**Floyd County Board of Commissioners
Ordinance Pertaining to Map Amendments to the Floyd County Zoning Ordinance**

Re: Floyd County PC Docket FC-10-22-46, FC-10-22-47 & FC-10-22-48 – Galena Commons Rezoning and Planned Unit Development Plan Map Amendments

REZONING PLAN
GALENA COMMONS
 6671 HIGHWAY 150
 FLOYD KNOBS, IN 47119
 PARCEL I.D. 22-03-01-100-259.000-004
 & 22-03-01-100-213.000-004

PLANNED UNIT DEVELOPMENT (PUD) BALLOT

RZ-01

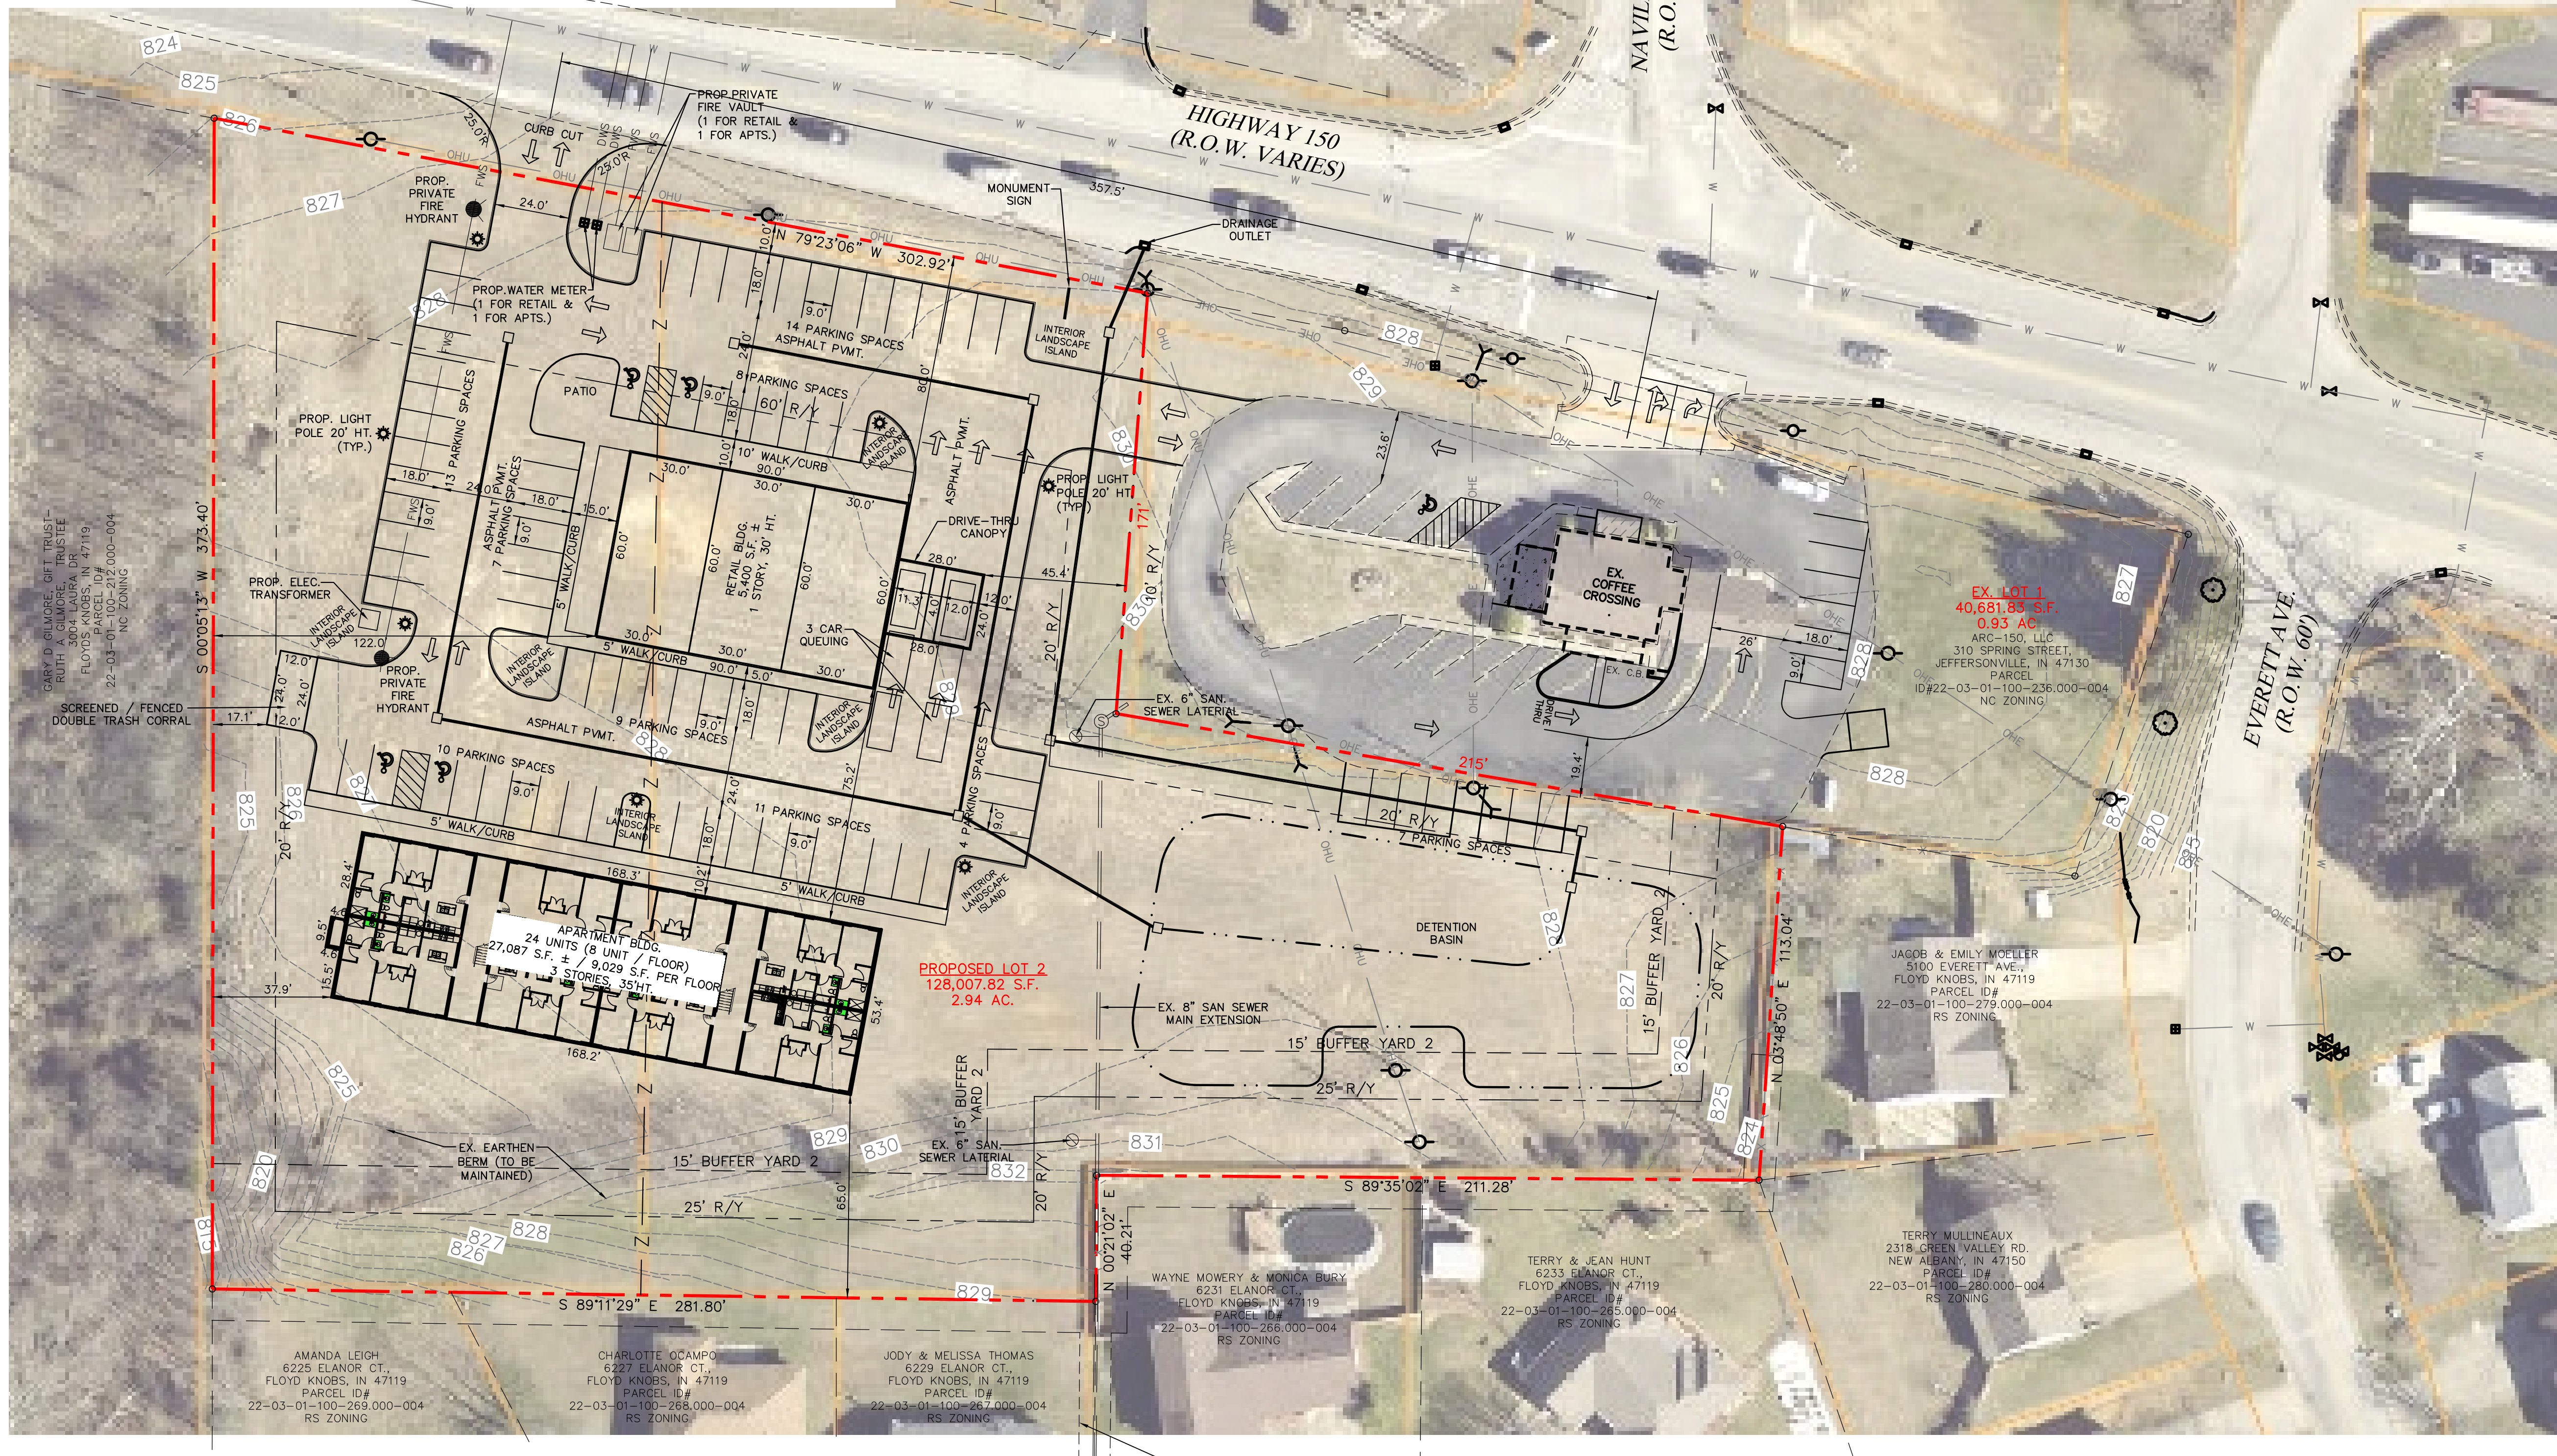
Specifically 5.09 Buffer Yard and 5.50 Pedestrian Amenities. The location of the rear buffer yard screening an existing berm is more than 10' from the property line and the existing berm is less than 6' in height. The proposed development does not provide a perimeter sidewalk along the right of way and internal sidewalks connecting parking and open space/common areas are missing.

The proposal does include adequate public services as demonstrated by the service providers letters. The proposal includes reasonable traffic circulation plan and has direct access to a high-volume state highway. The proposal provides the required open space but a large portion of it is used for the detention basin. Additional common space/recreational amenities are recommended such as picnic area/tables, benches, playground etc.

The site has direct access to Hwy 150 and secondary access to the traffic light intersection at Navileton Road. A permit form INDOT will be required to ensure service and extending the deceleration lane is recommended.

- A. Drainage will not be harmful or detrimental to downstream neighbors and will be approved by Floyd County Stormwater Board.
- B. Developer will provide a deceleration lane on Highway 150 to be extended as approved by INDOT and the County Engineer.
- C. Provide a joint use agreement for shared parking and access drive with the adjoining property (Coffee Crossing).

- A. Stormwater detention approvals are required prior to secondary approval
- B. An INDOT permit for the Highway 150 entrance is required prior to secondary approval.

- C. Extend the deceleration lane as approved by INDOT and the County Engineer. *for the new entrance*
- D. The landscaping, lighting and signage plans are required prior to secondary approval and must be consistent with Multi-Family Standards or as approved by the Planning Commission.

- E. The buffer yard will utilize the existing berm (as is) with additional plantings and a six-foot fence within ten feet of the property line. Where there is no existing berm (east side of property) a six-foot fence is required within ten feet of the property line with plantings. Plantings will be consistent with the buffer yard 2 density.

- F. Provide additional outdoor recreational amenities for multi-family, such as walking path, playground, benches/picnic area, etc.
- G. Internal sidewalks are required to provide access to parking lots and open space (east and west parking spaces).

- H. Project will meet the fire protection conditions stipulated by Lafayette Township Fire department letter dated 10/18/2022.
